Access Compliance Report

Public Rights-of-Way

(Curb Ramps)

| Intersection ID: 6481 | Main Street: LOTHAR RIDGE LN | Cross Street: SLATER SPRINGS DR | Location: NW |

| ADA ID: 075ED09ED236 | Ramp Type: Perp | Initial Pass/Fail: Fail | Overall Compliance: No |

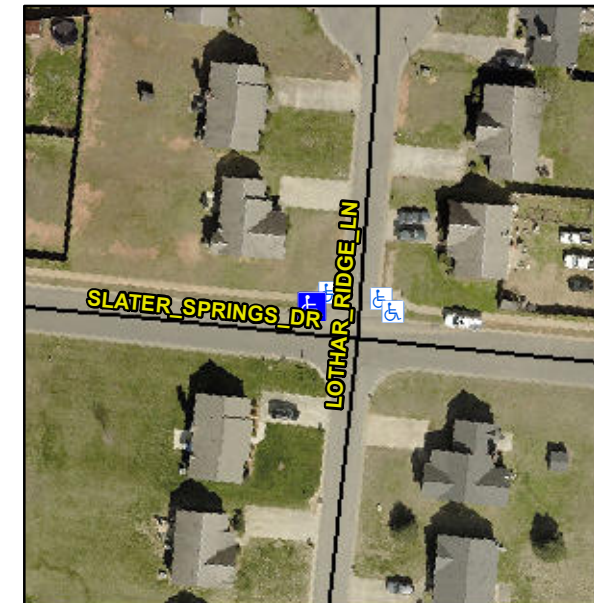
Not Found, R304.5.1, R304.5.3

| Compliance | Description | Data | Compliance | Description | Data |
|------------|-----------------------|------|------------|-----------------------------|------|
| No | Ramp Width (in) | 42.5 | No | Ramp XSlope (%) | 2.3 |

Remove & Replace Entire Ramp.
